Date: 08/17/2021  
 Facility Name: Hawthorn Recycling and Disposal Facility  
 Permit or Registration No.: MSW-2185A

**RESPONSE TO TCEQ INFORMATION REQUEST  
PERMIT AMENDMENT APPLICATION  
USA WASTE OF TEXAS LANDFILLS, INC.  
HAWTHORN PARK RECYCLING & DISPOSAL FACILITY, TCEQ PERMIT MSW-2185A  
HOUSTON, HARRIS COUNTY, TEXAS  
TRACKING NO. 25937311, 26099680; RN102664232 / CN602560930**

**LIST OF REVISED/NEW PAGES**

PROJECT  
 HAWTHORN PARK RECYCLING & DISPOSAL FACILITY  
 PERMIT AMENDMENT APPLICATION  
 TCEQ PERMIT NO. MSW-2185A  
 TITLE  
**CELL LAYOUT PLAN**  
 PROJECT NO. 1894269 APPLICATION SECTION II REV 2 5 of 25 FIGURE II-5

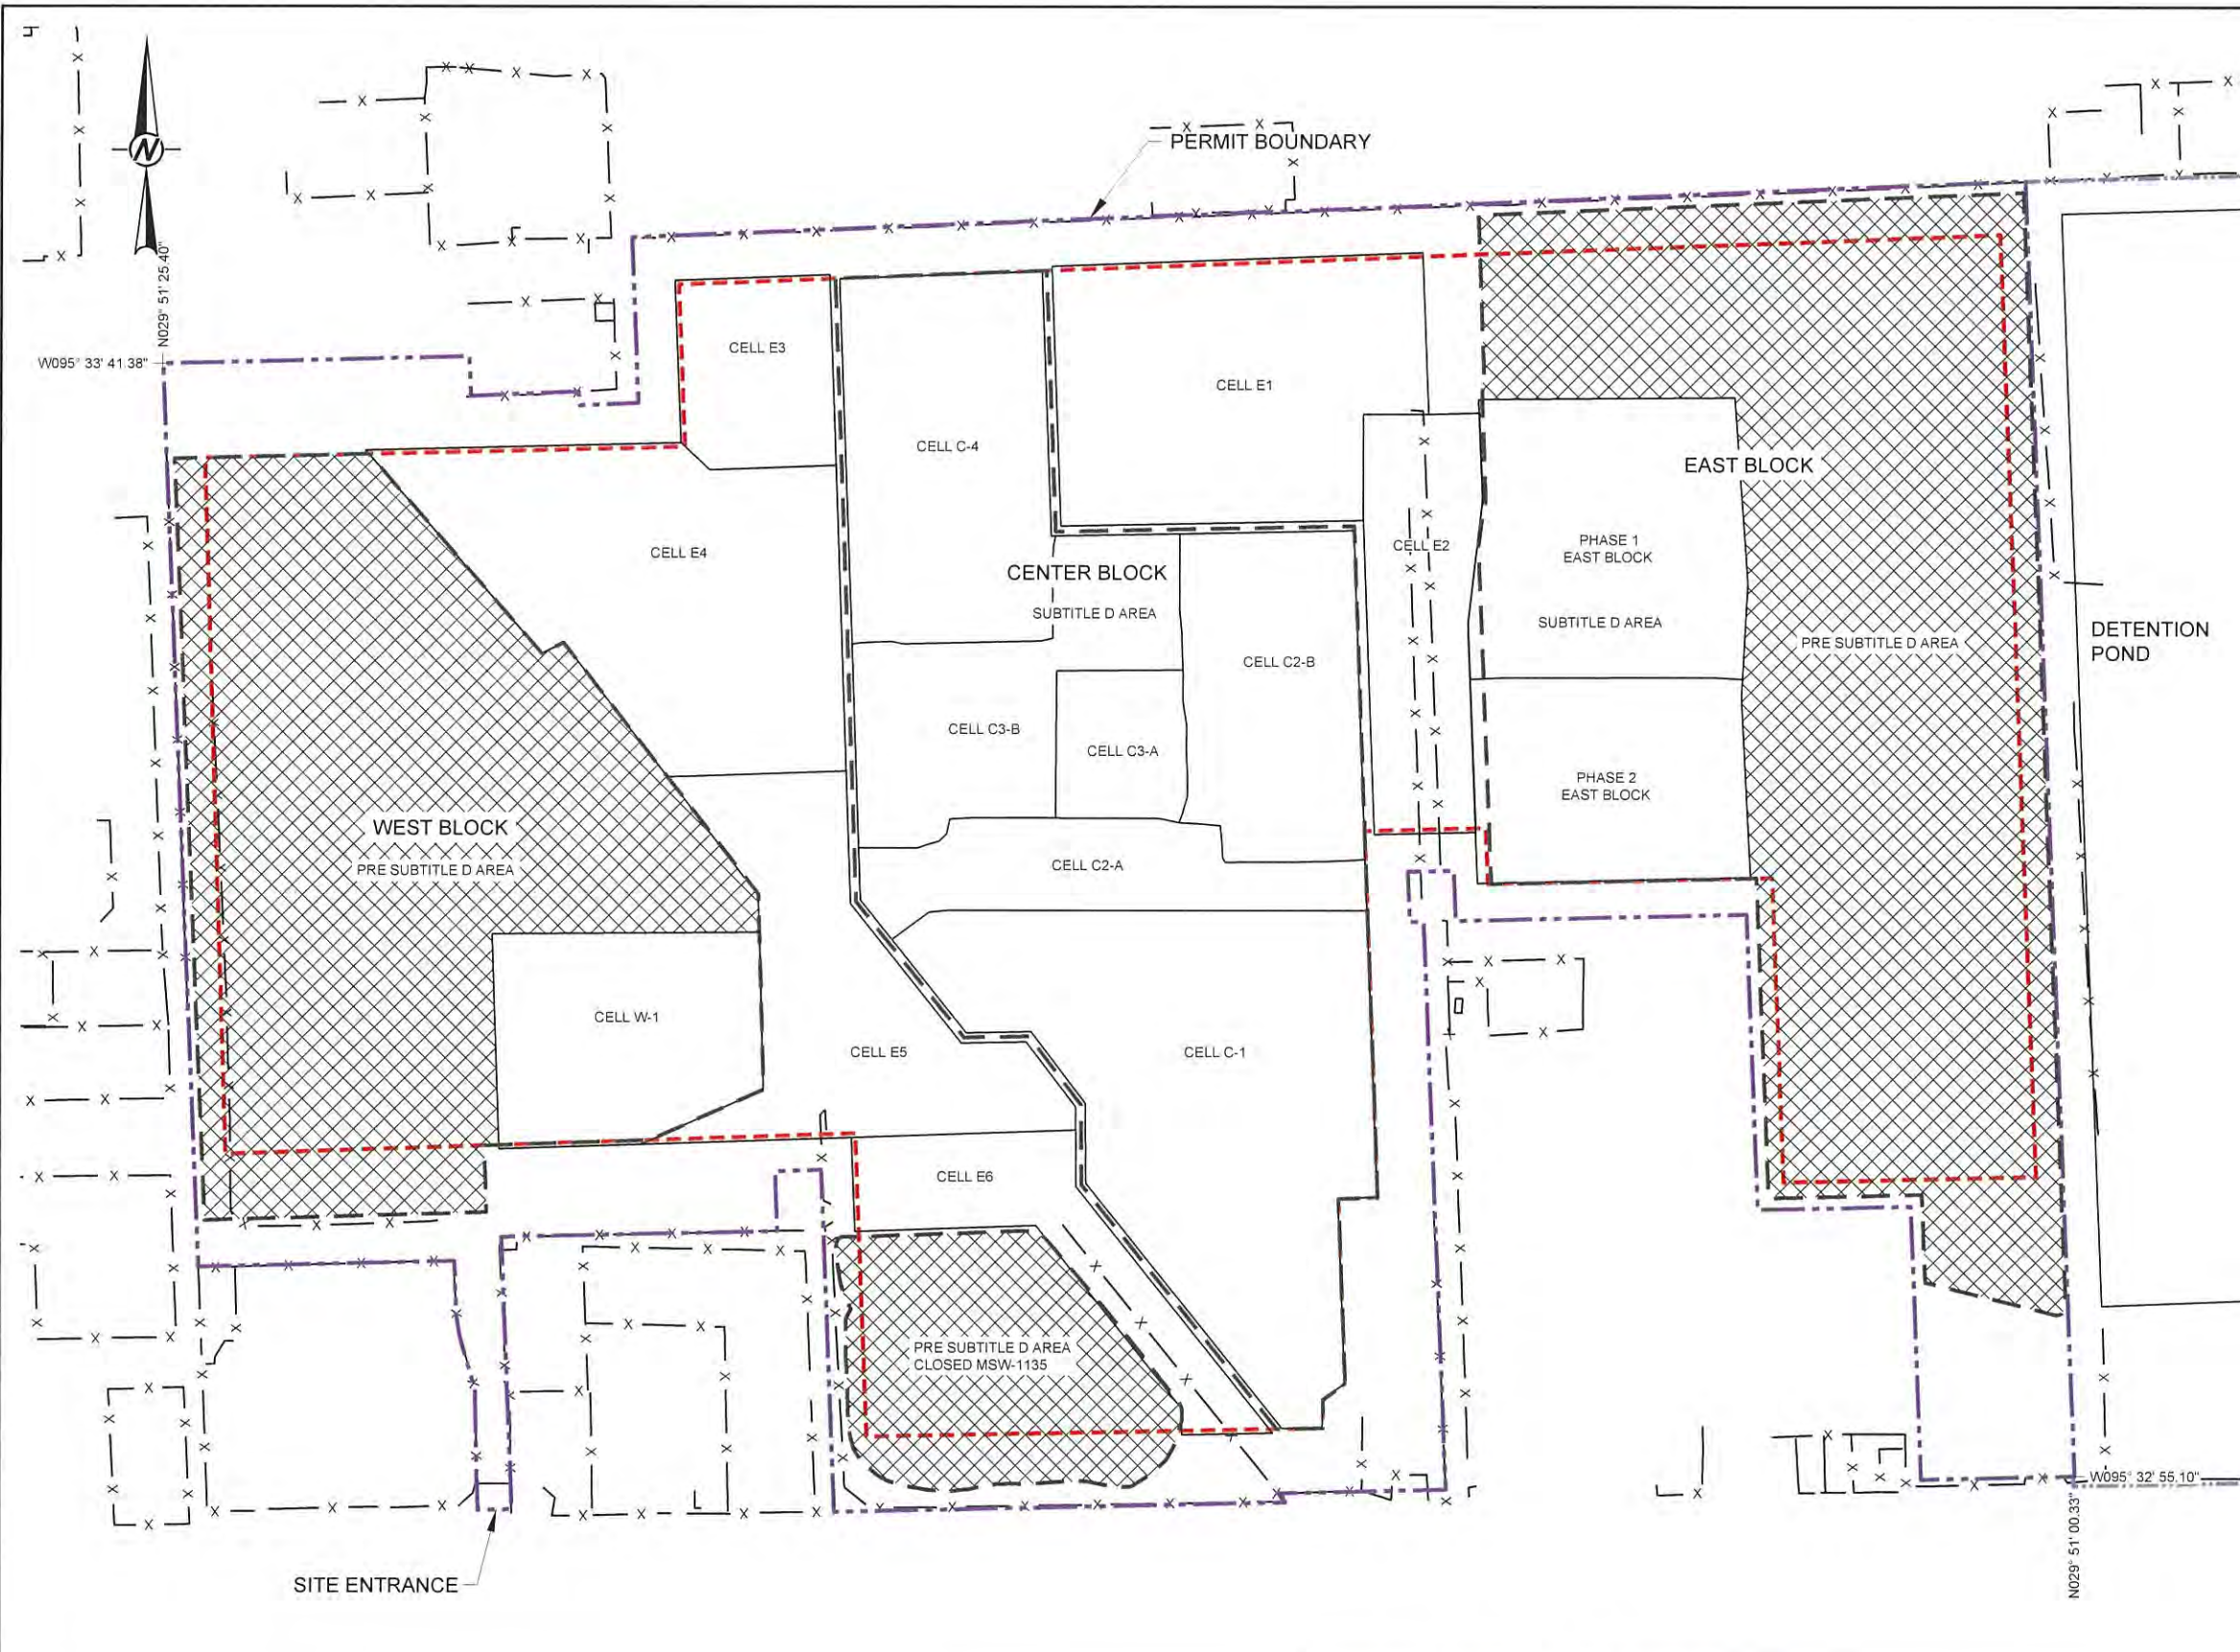
NOD ID	MRI ID	App. Part	Citation	Location	3 <sup>rd</sup> NOD Type	NOD Description	Response
T6	400	Part III	330.339(a)(2)	Attachment 3, Appendix III-3D, Section 2.3	Ambiguous	Specify and provide the design details that the liner is continuous over the whole waste area within the permit boundary. Staff notes that the previously closed landfills may contain separated unit/cell design that the liners may be discrete.	<p>As described in the response to comment T4, the design details for permitted facilities at the site are included in TABLE III-3D-1: Existing Liner Systems in Part III, Attachment 3, Appendix III-3D Liner Quality Control Plan (LQCP). A new figure (Figure III-3D-6) has been developed to show the cell layout for MSW-1643 and demonstrate the contiguous development of cells within the permitted disposal footprint. Documentation reviewed for each of these cells indicates that the evaluated liner “complies with the groundwater protection requirements contained in this Department’s [Texas Department of Health] ‘Municipal Solid Waste Management Regulations.’” The in-place liner system or constructed overliner system discussed in the response to comment T4 will provide a contiguous liner system over the areas of Permit Nos. MSW-1135, MSW-1448, and MSW-1448A.</p> <p>The new Figure III-3D-6 was developed from the Cell Layout Plan in the Part II figures (Figure II-5) of the Permit Amendment Application. Figure II-5 was revised and is provided with this response.</p>

**MSW SITE  
WITH  
GROUNDWATER FLOW DIRECTION  
AT OBLIQUE ANGLES TO SITE BOUNDARY**

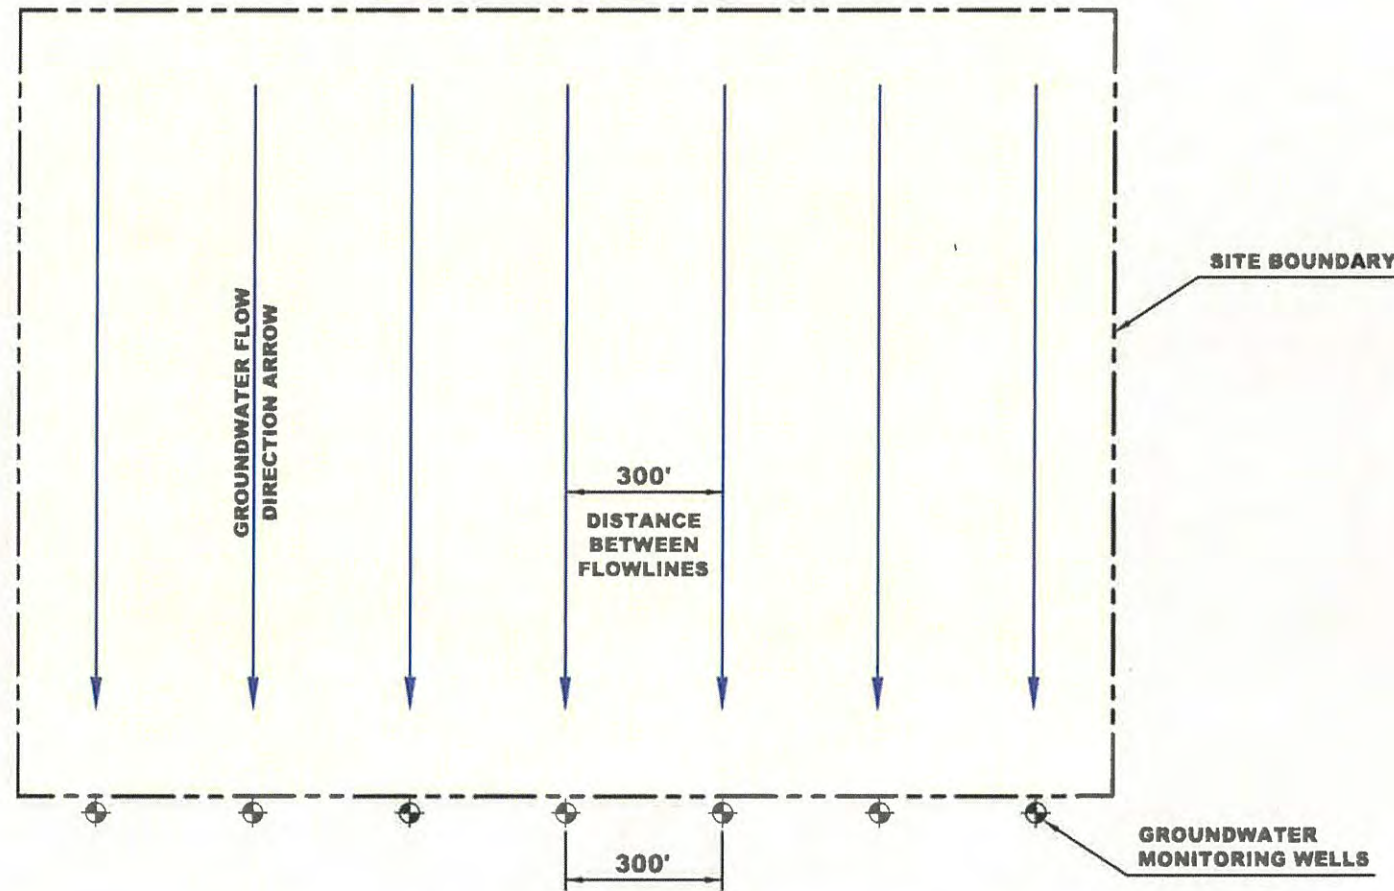
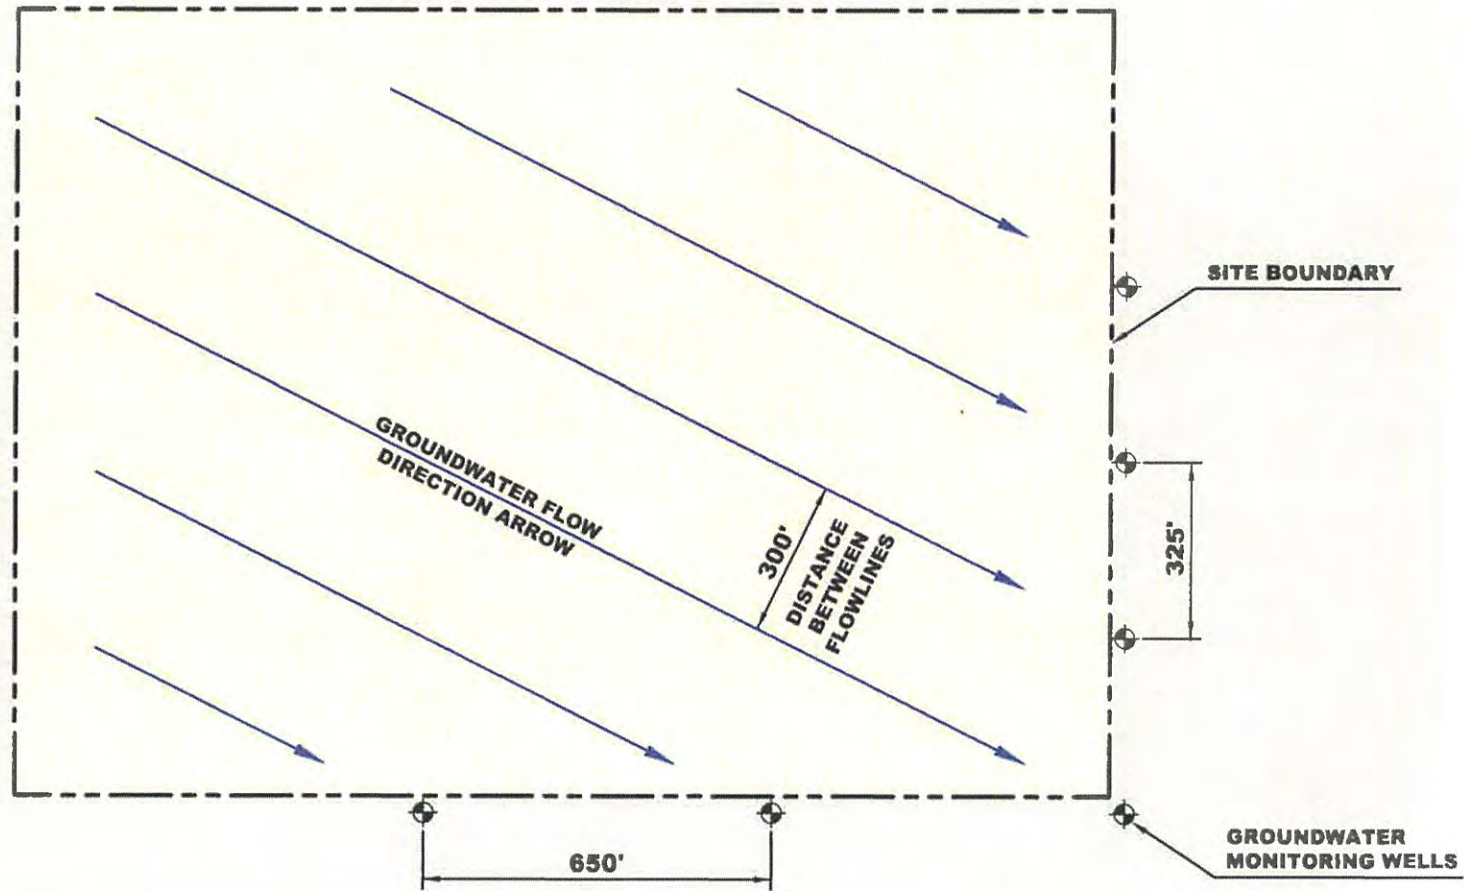
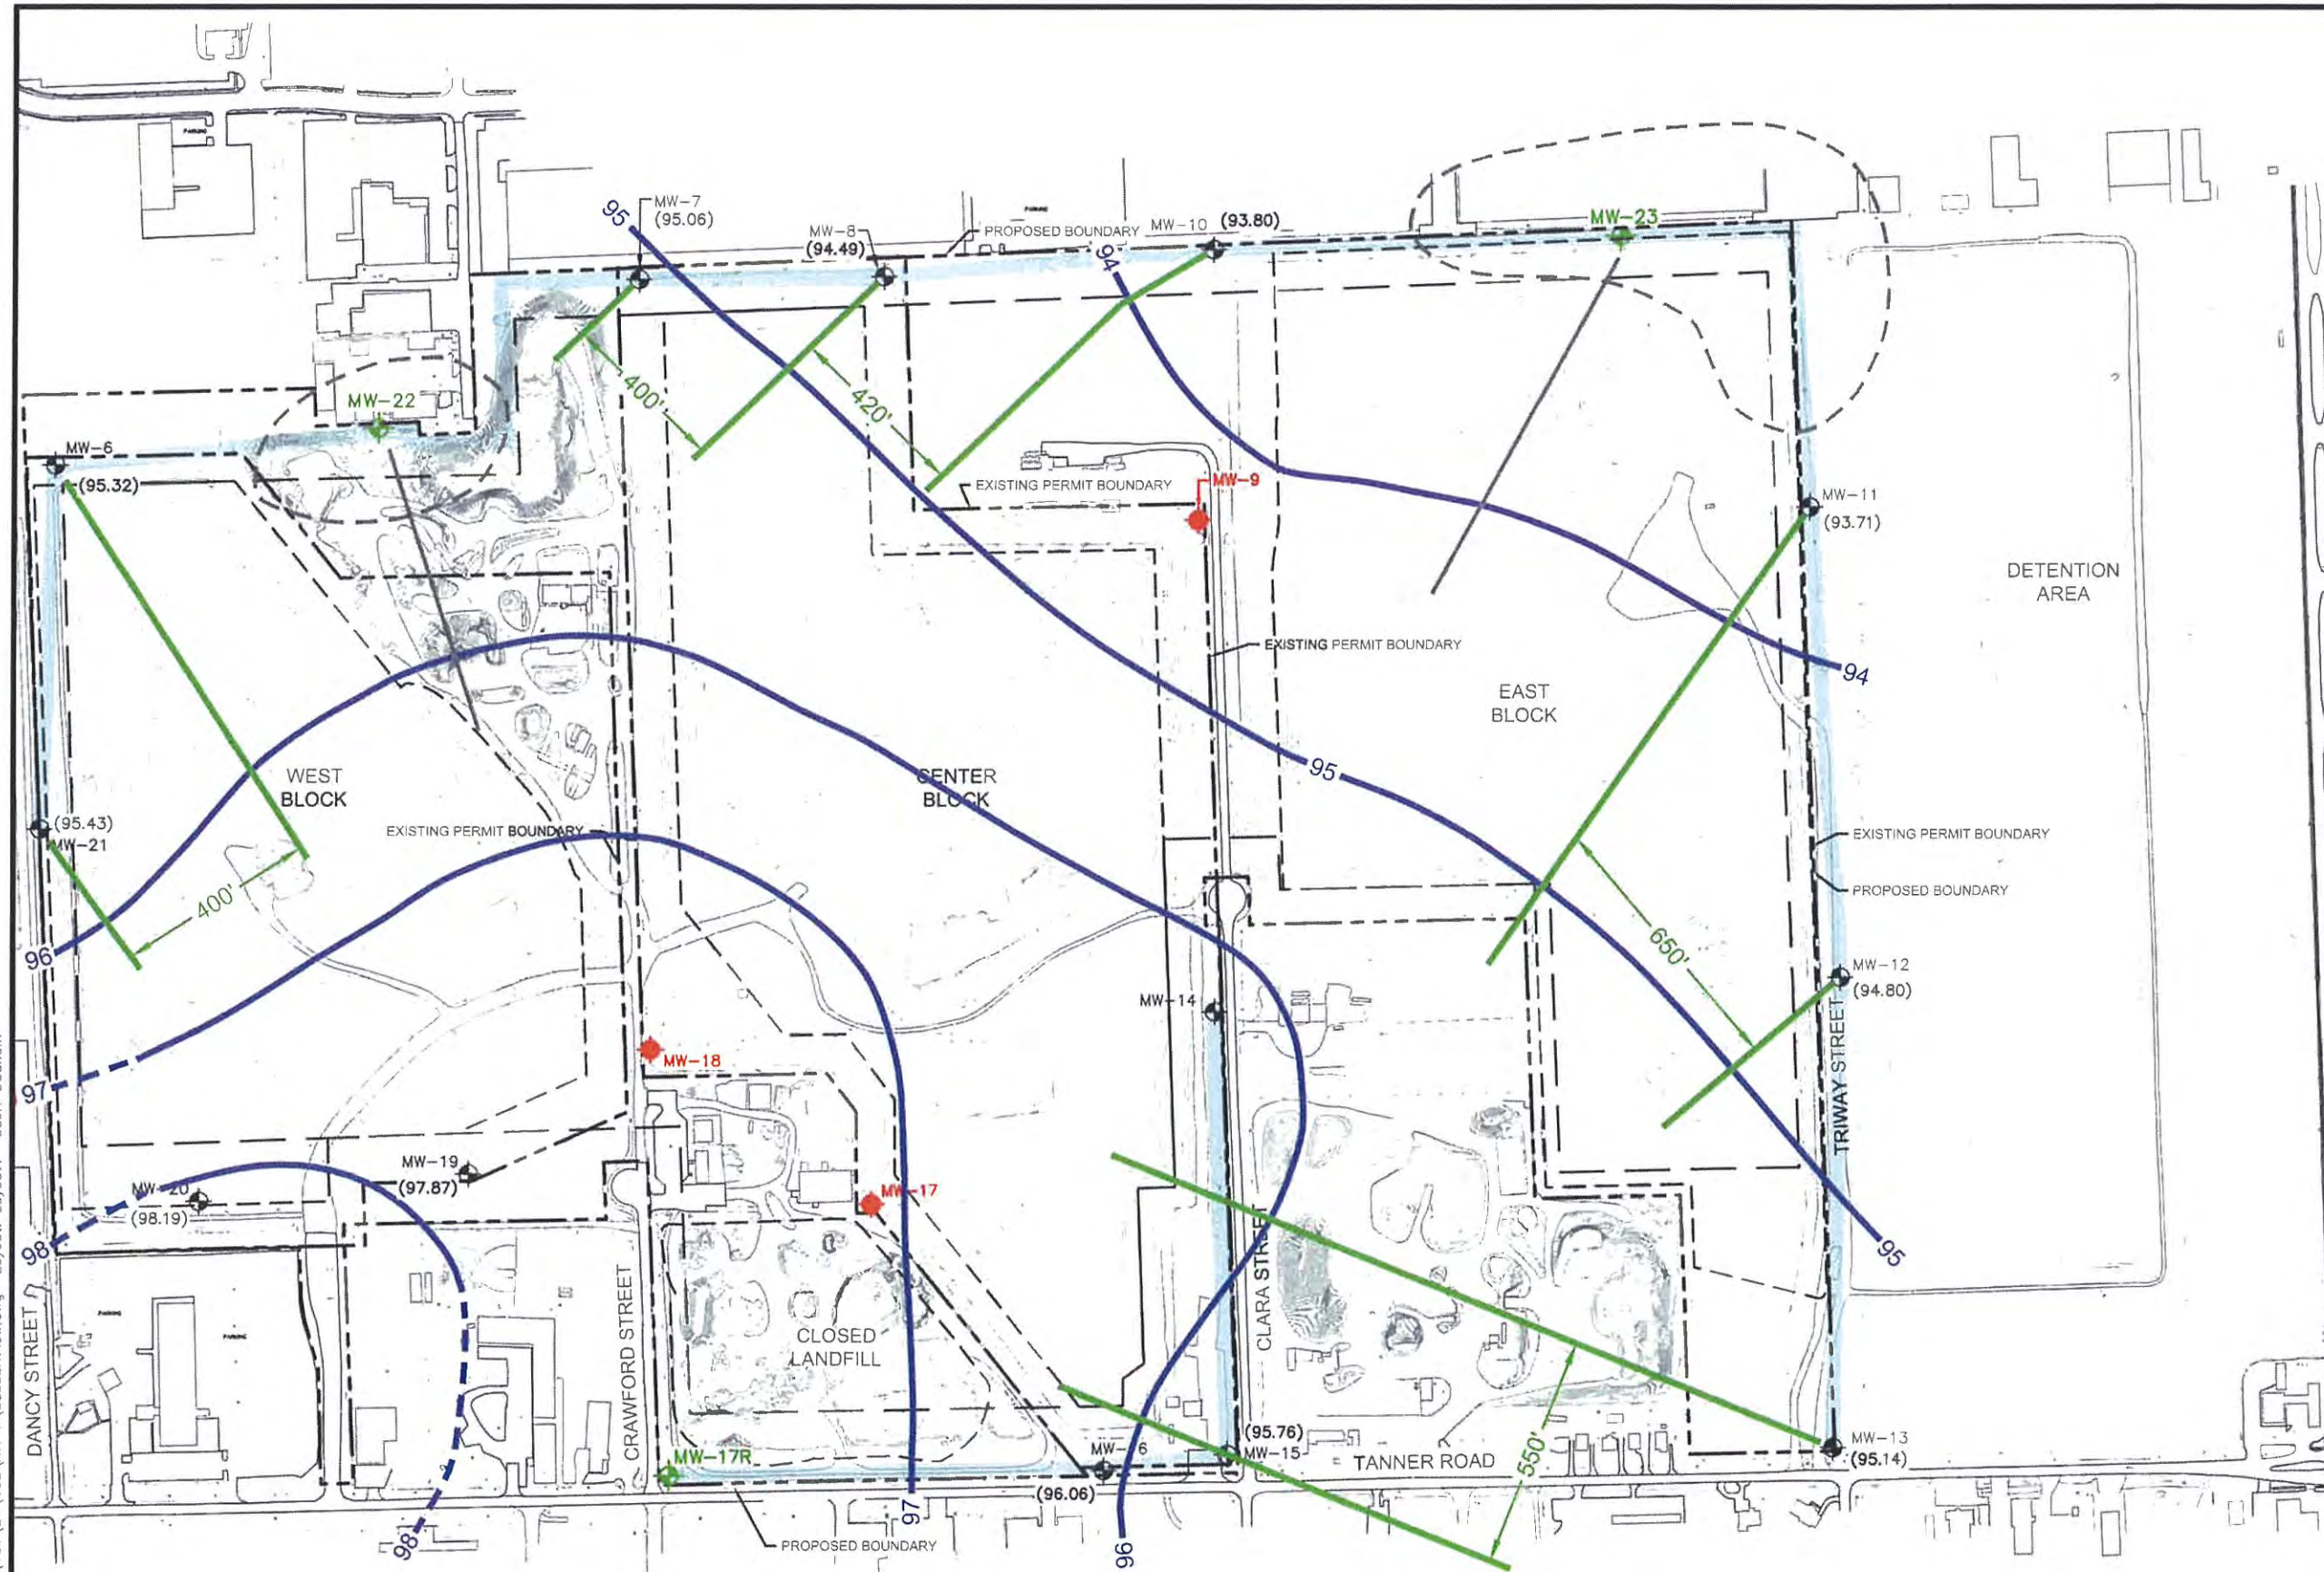
T7	556	Part III	330.403(a)	Attachment 5, Section 2.3	Ambiguous	Explain the choice of monitoring well spacing, specifically how the widely variable well spacing shown in Figure III-5A-1 (500 to 1000+ feet) will yield representative groundwater samples throughout the monitoring system.	<p>The approved existing groundwater monitoring network at Hawthorn Park Landfill, a Type IV facility has a limited point of compliance (POC) with 5 downgradient monitoring wells. The monitoring well spacing currently ranges from a minimum of 300 feet and a maximum of 800 feet along the POC. The TCEQ regulations have no requirement for spacing between monitoring wells at Type IV facilities.</p> <p>The existing groundwater monitoring network was designed based on the groundwater flow regime active at the time. Dewatering and depressurization activities had created an inward groundwater gradient at the site.</p> <p>Groundwater approaches the POC at the facility at an oblique angle and as such, it is important to consider the effective spacing of monitoring wells (measuring between flow lines to determine distance between monitoring wells). When measuring the spacing between flow lines (perpendicular to contour lines) spacing is typically from 200 ft between MW-15 and MW-16 to 1400 ft between MW-10 and MW-11 and 1,110 ft between MW-6 and MW-7. Most other spacing is between 400-600 ft when measured between flow lines. For those two widely space segments, between MW-10 and MW-11, and between MW-6 and MW-7, we have proposed a new well (monitoring wells MW-22 and MW-23) in each segment that reduces spacing to 600 – 800 ft between flow lines. With the addition of the proposed wells now overall downgradient wells are spaced from 200 to 800 ft apart as measured between flow lines. An exhibit depicting this has been included with this response.</p> <p>In summary, the proposed groundwater monitoring network has total of 16 monitoring wells (14 downgradient wells) spaced ranging from 200 ft to 800 ft between wells when measured between flow lines.</p>
